ENCLOSURE 1

PROPOSED CHANGES TO TECHNICAL SPECIFICATIONS
BROWNS FERRY NUCLEAR PLANT
UNIT 1

EXPLANATION OF CHANGES

Figure 3.5.K-1
MCPR LIMITS*

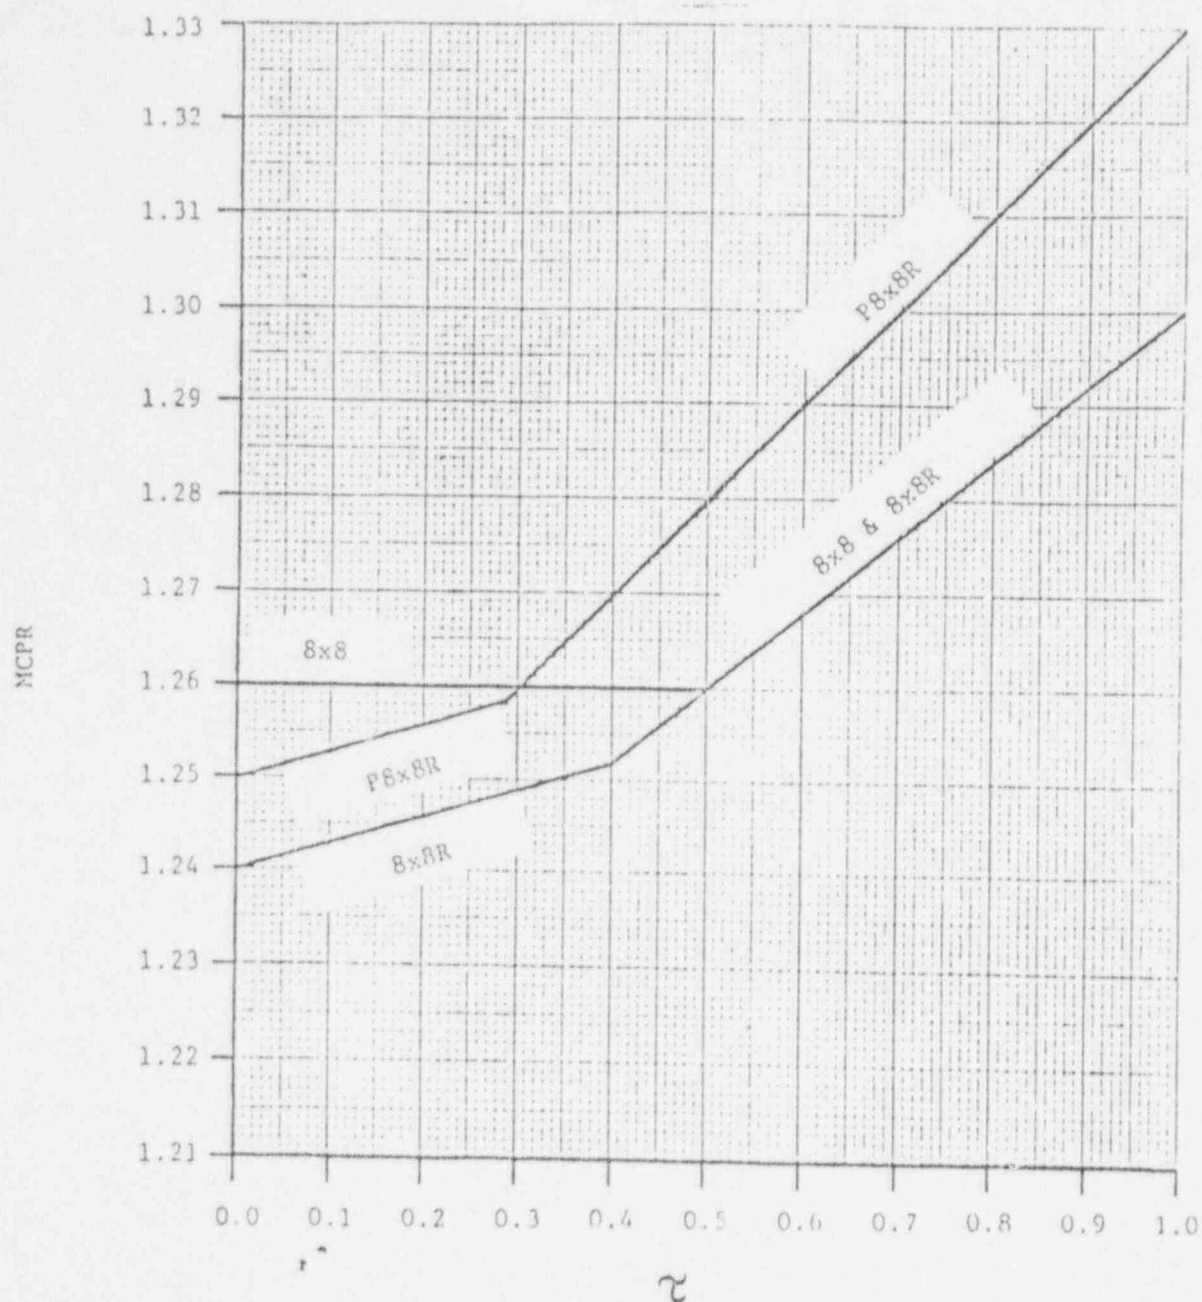
The minimum critical power ratio (MCPR) as a function of scram time and core flow, shall be equal to or greater than shown in Figure 3.5.K-1 multiplied by the K_f shown in Figure 3.5.2, where:

2. The MCPR limit shall be determined for each fuel type 8X8, 8X8R, P8X8R, from figure 3.5.K-1 respectively using:
